FIGURE 3.1-1 ROD GROUP INSERTION LIMITS VERSUS
THERMAL POWER 4 LOOP OPERATION

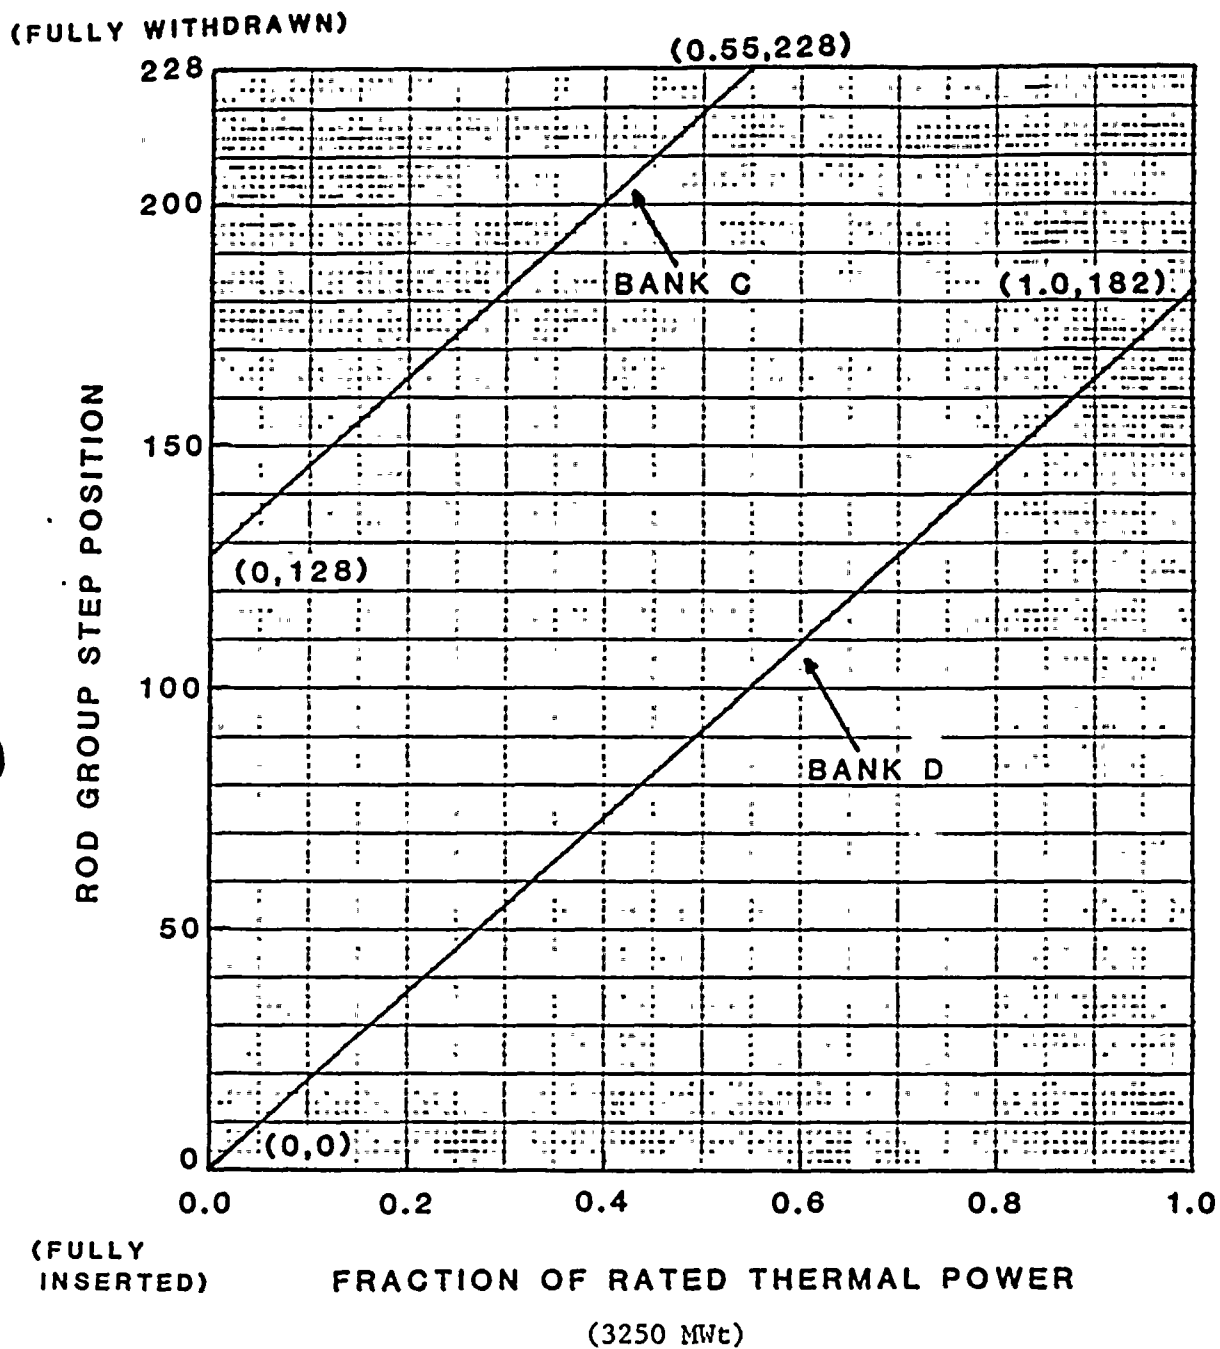
3/4 1-24; 3/4 1-25; 3/4 1-26	Figure 3.1-1 Figure 3.1-2	1	*	056	Rod Group Insertion Limits figure for 4 Loop Operation is redrawn with labeled endpoints.	Editorial change. See memo dated February 26, 1986, from F. J. Silva to J. C. Miller of Westinghouse Electric Corporation found in Attachment 7.
		2	*	057	Rod Group Insertion Limit figure for 3 Loop Operation is removed.	Three loop operation in Modes 1 and 2 will be prohibited.
		1		058	Rod Group Insertion Limit figure for 4 Loop Operation is renamed Figure 3.1-1.	Editorial change.
		1		059	Pages 3/4 1-25 and 3/4 1-26 are removed.	Editorial change; blank pages are unnecessary at the end of a section.

FIGURE 3.2-2 EXXON FUEL
K(Z) NORMALIZED VS. CORE HEIGHT

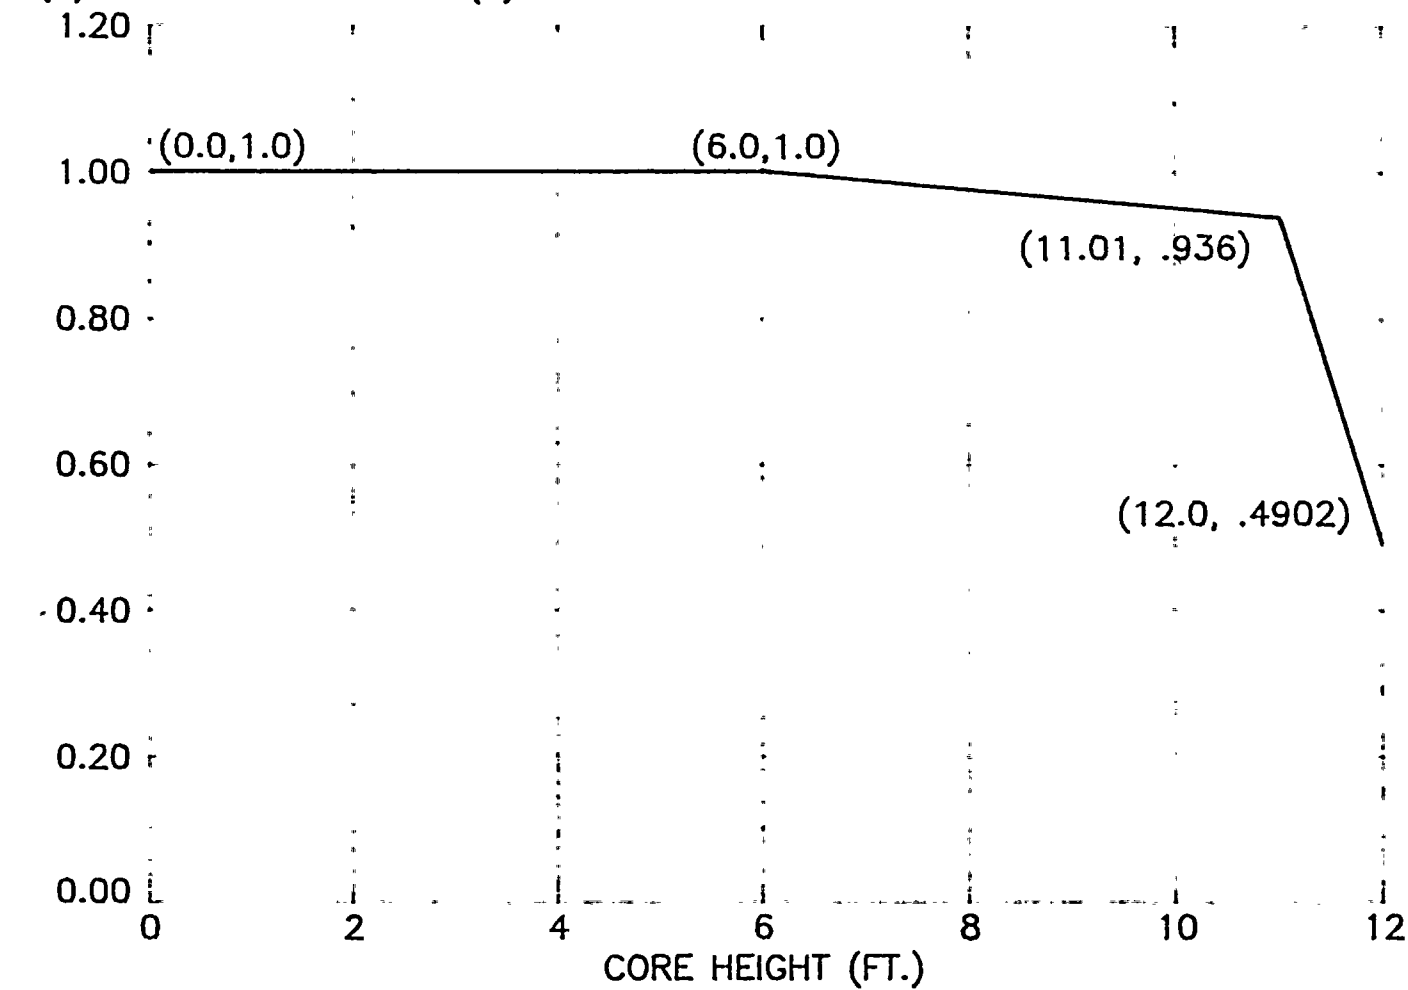
3/4 2-10	Figure 3.2-2	1	*	076	The figure is redrawn.	Editorial change for clarity.
		1		077	The page number is changed to 3/4 2-7.	Editorial change.
3/4 2-11	Figure 3.2-3	1		078	The figure is redrawn.	Editorial change for clarity.
		1		079	The page number is changed to 3/4 2-8.	Editorial change.
3/4 2-12	3.2.3	1		080	Mathematical symbols are written out in words.	Editorial change for clarity.
		1		081	"power" is changed to "POWER".	Editorial change. Thermal power is a defined term.

Figure B 3/4 2-1 TYPICAL INDICATED AXIAL FLUX DIFFERENCE
VERSUS THERMAL POWER AT BOL

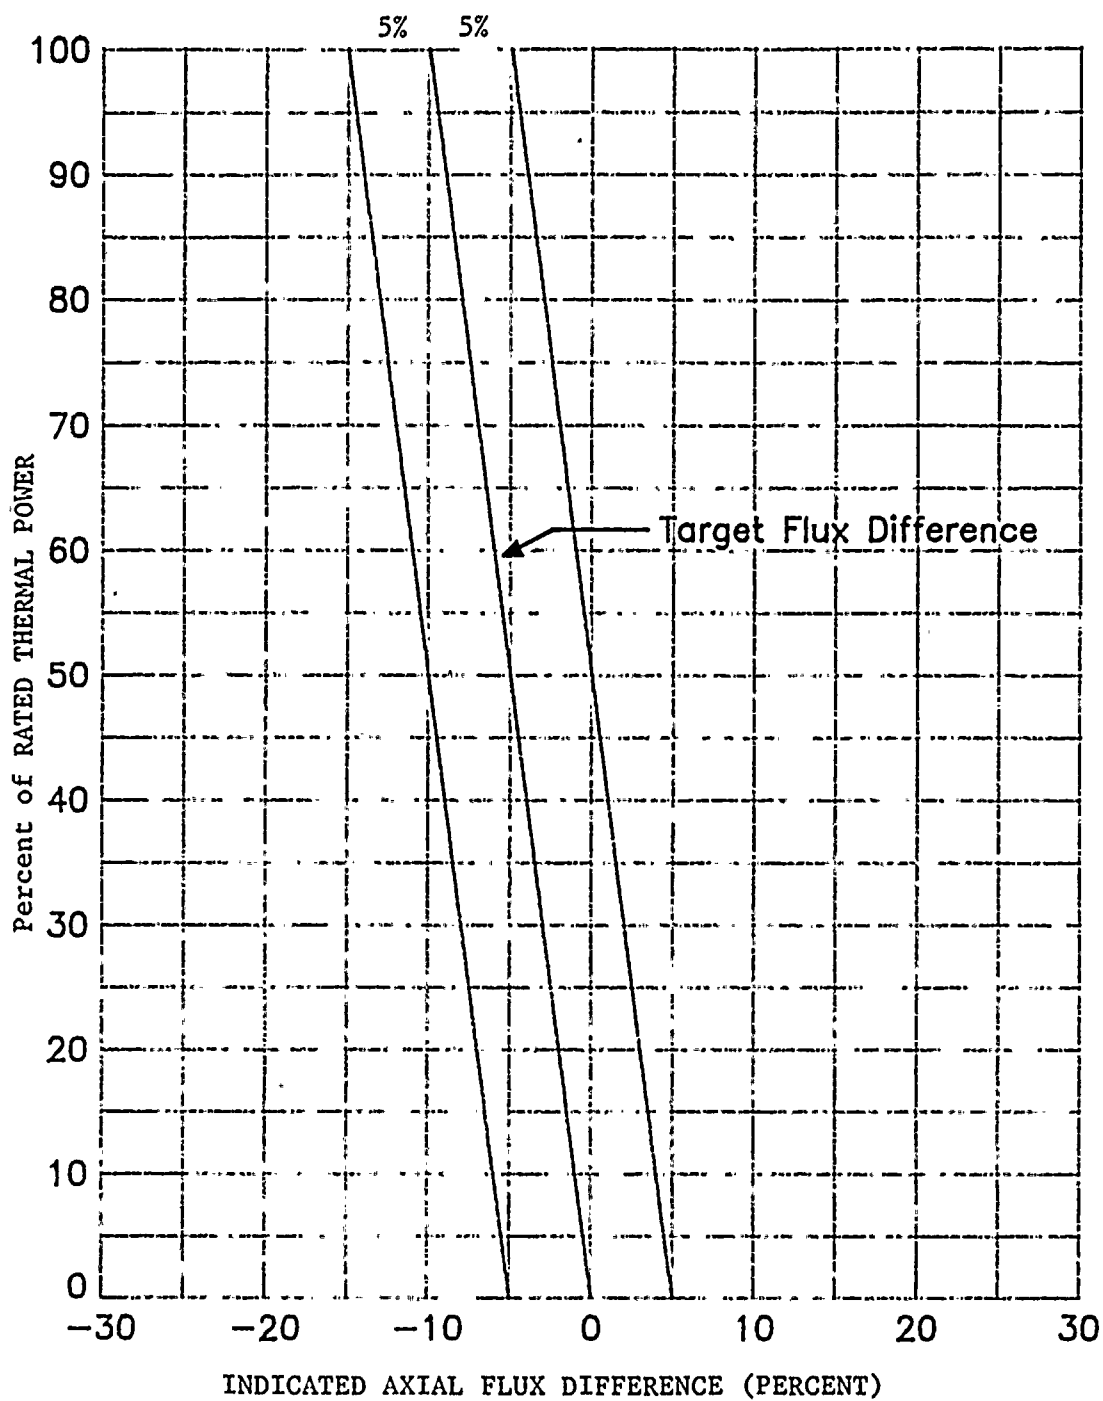
PAGE	SECTION	+ * #	DESCRIPTION	REMARKS
		B	212a Period replaced by comma.	Editorial change.
B 3/4 2-3	Figure B 3/4 2-1	B	212b Figure is redrawn.	Editorial change for clarity.
B 3/4 2-4	3/4.2.2 3/4.2.3	B	213 The words "nuclear enthalpy hot channel factor" changed to "nuclear enthalpy rise hot channel factor".	Editorial change; makes Technical Specifications for both units more similar.
		B * 214	References to F_O and F_{AH} expanded to include proposed APL Technical Specification.	Editorial change.
		B	215 (No change for this identifier).	
B 3/4 2-5	3/4.2.3	B	216 "physics tests" is changed to "PHYSICS TESTS".	Editorial change; physics tests is a defined term.
		B	217 Section on burnup dependent F_Q for Exxon fuel removed.	See remarks for Item 208.
B 3/4 2-6	3/4.2.5 (Bases)	B * 218	Discussion of flow rate surveillances are included.	Surveillance requirements revised to add CHANNEL CALIBRATION and flow measurement. Monthly flow surveillance is removed as redundant to shiftly surveillance. Resulting surveillance requirements are consistent with Unit 2 Technical Specifications. See Attachment 6, Item Number 10.

FIGURE 2.1-1 Reactor Core Safety Limits -
Four Loops in Operation

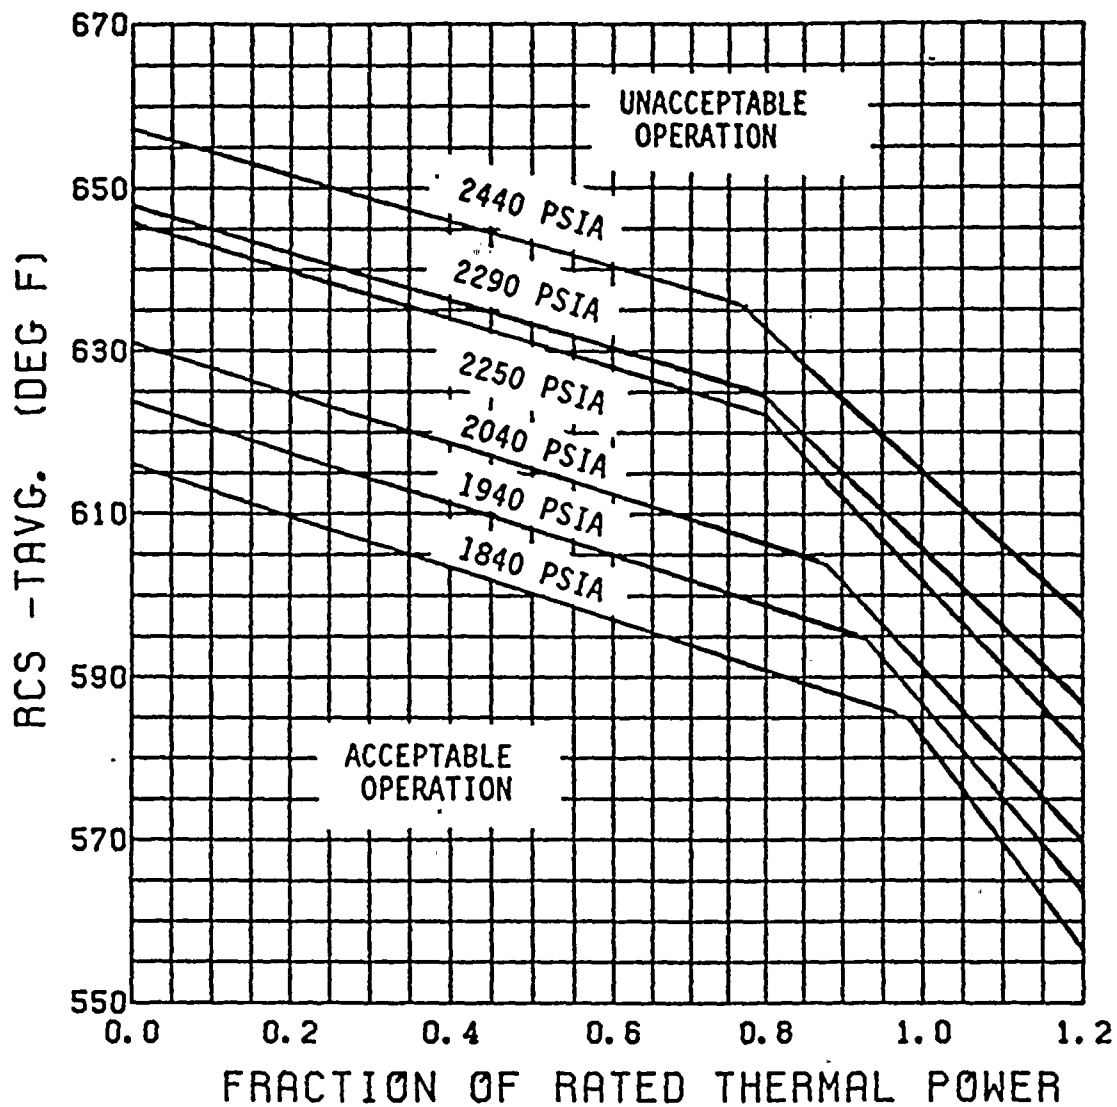
PAGE	SECTION	+	*	#	DESCRIPTION	REMARKS
2-2	Figure 2.1-1	1		231	Curve for 2250 psia is added.	Editorial change. See letter dated July 31, 1986, ENC-AEP/0511, H.G.Shaw to D.H.Malin found in Attachment 10.
3/4 1-3	4.1.1.2	1		232	Change "greater than" to "greater than or equal to".	Editorial change. Makes Unit 1 and Unit 2 more consistent.
		1		232a	Mathematical symbols are written out in words.	Editorial change for clarity.

FIGURE 3.1-2

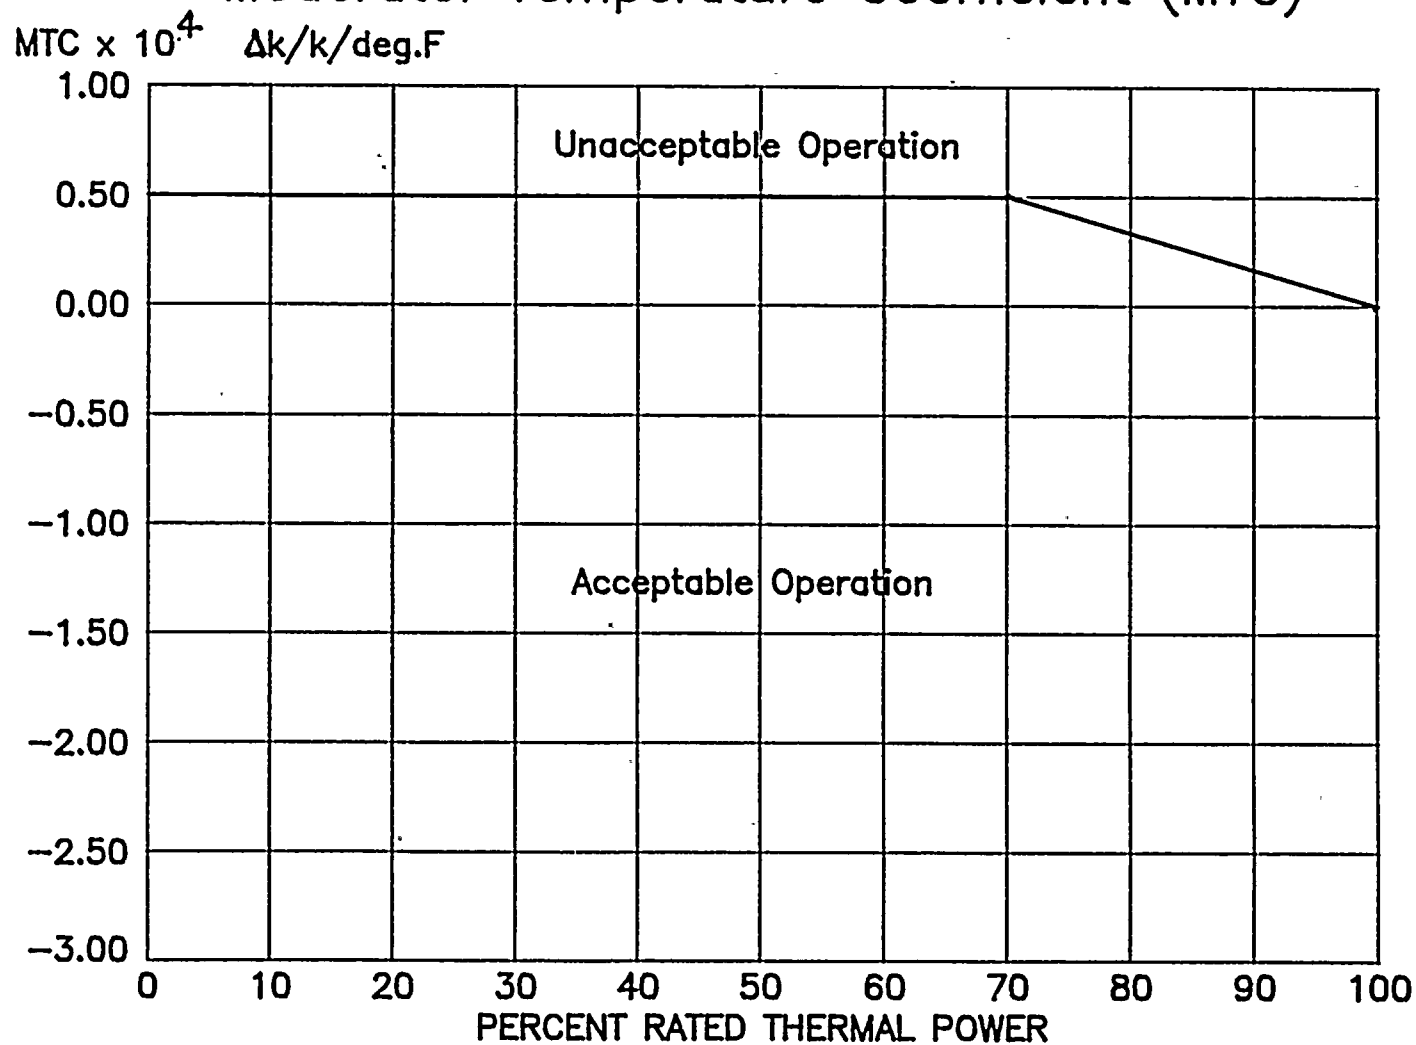
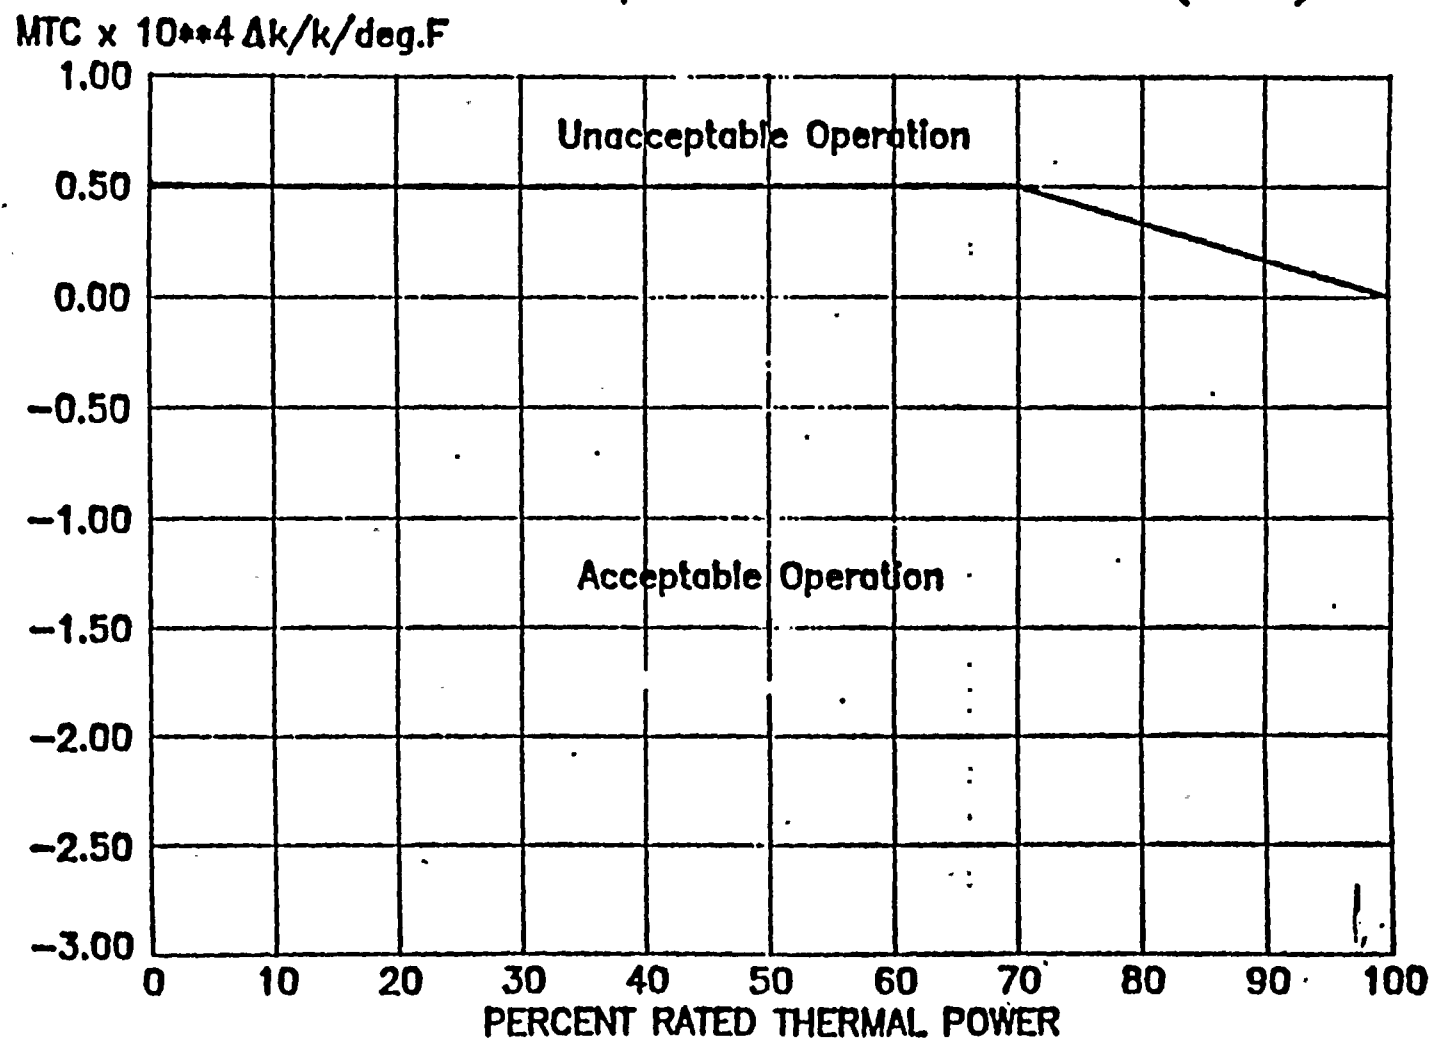
3.1.1.4	8		235	The upper limit on MTC for operation above 70% RTP is changed. The upper limit is now graphically displayed (see Item 238).	To improve operational flexibility. Justification provided in Attachment 10.
3/4 1-5; 3/4 1-6; 3/4 1-6a	Figure 3.1-2

4.1.1.4.b	1		236	Specified 300 ppm surveillance at "RATED THERMAL POWER equilibrium boron concentration".	Editorial change; change made to clarify the intent of the surveillance requirement.
		1		237	Mathematical symbols are written out in words.	Editorial change for clarity.
		1		238	The new MTC limits proposed in Item 235 are now graphically displayed in Figure 3.1-2 on new page 3/4 1-6a.	Editorial change.
